REPUBLIC OF NICARAGUA
TIPITAPA-TAMARINDO PROJECT
ANALYSIS OF USBR REPORT

1.- OBJECTIVE

2.- OBSERVATIONS AND COMMENTS

FIGURE 1

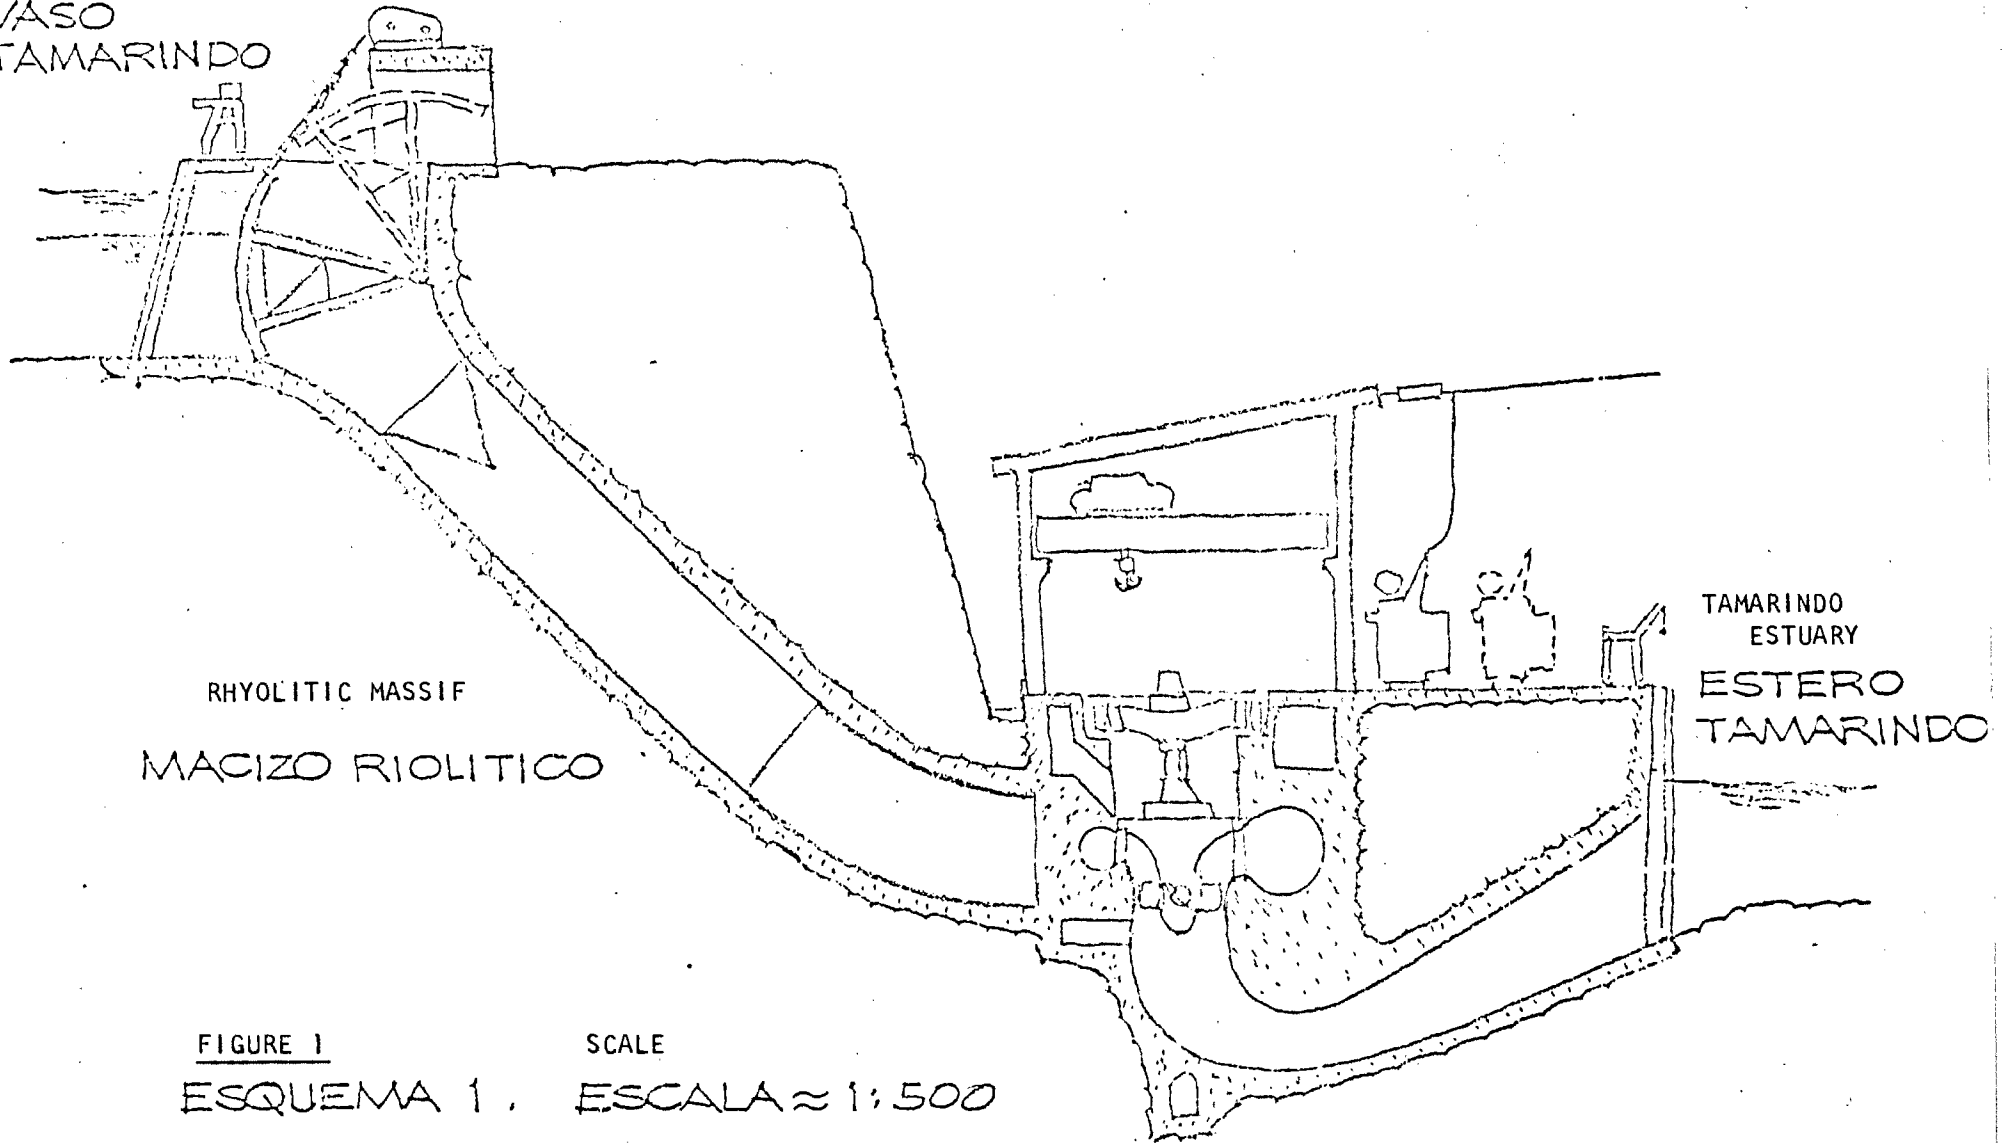
L 154.- The argument used to reject the alternative sites for the Tamarindo dam and powerplant is groundless. Actually:

- a) An intake structure as high as the dam is not necessary if the water level variations in the reservoir do not even reach one tenth of the height.
- b) For a dam with a 7 500 000 m³ volume of materials, the type of construction described on page 185: "steel penstocks, encased in concrete, and built by cut and cover methods" placed under the dam and along its main section, is unacceptable unless there were no other option.

If this solution is unsatisfactory for the proposed site, where the length of the penstocks is approximately 200 m, the extrapolation of this figure to more than 2 000 m for the purpose of ascertaining the merits of a second alternative site creates a monumental error which leads to the false assertion that "the second alternative was estimated to be from \$50 000 000 to \$100 000 000 more expensive than the Tamarindo Dam alternative".

Considering the proximity of the rhyolitic massif to the Tamarindo River, a design such as the one shown in Figure 1, logical from the standpoint of water intake and passage, allows the selection of a damsite which requires less than one tenth of the volume of materials shown in the Report. Waste from the excavation of the tailrace channel, as far as the rhyolites are concerned, could be used for the previously mentioned dam. An in-depth study would identify the most convenient site for the powerhouse. Figure 2 shows a possible site which, without pretending it to be optimum, would serve to demonstrate, together with Figure 1, that the argument advanced to accept the proposed site lacks validity.

FIGURE 3

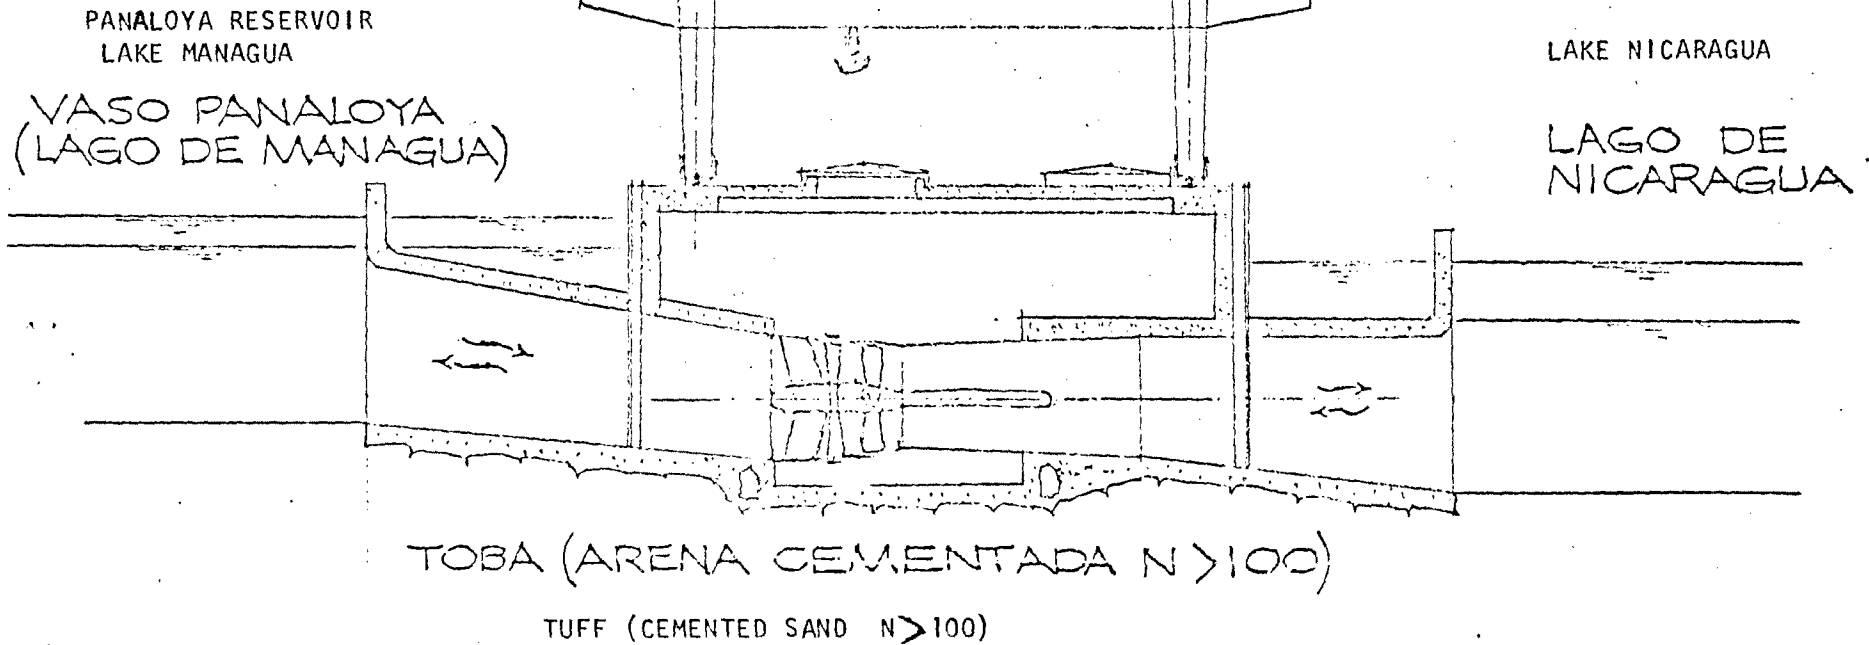
N 174.- To express in written form all the data and commentary for the pumping plant is not considered appropriate. Regardless whether the plant is located at Libano or Panaloya, the general description of and the proposed characteristics for the equipment are incomplete from the standpoint of investment, energy balance, immediate and long term operating modes, and other factors associated with the amount of water that has to be pumped and the low pumping head.

The most effective way to show the above data is to present them as in Figures 3, 4 and 5, which refer to a plant at Panaloya, with four 9 MW reversible units, 200 m³/s, 3.75 m of dynamic design head and present no special difficulties given the present state of the art, resulting from an evolutionary process that has been going on for almost half a century, but was ignored in the Report.

The objectionable features of the Report discussed under K 154 and L 154 are sufficient to justify its total revision and the preparation of a completely new document. Figures 3, 4 and 5 are presented to demonstrate that it is possible to adopt logical configurations, although not optimized, which could be applicable to the special features of the Project.
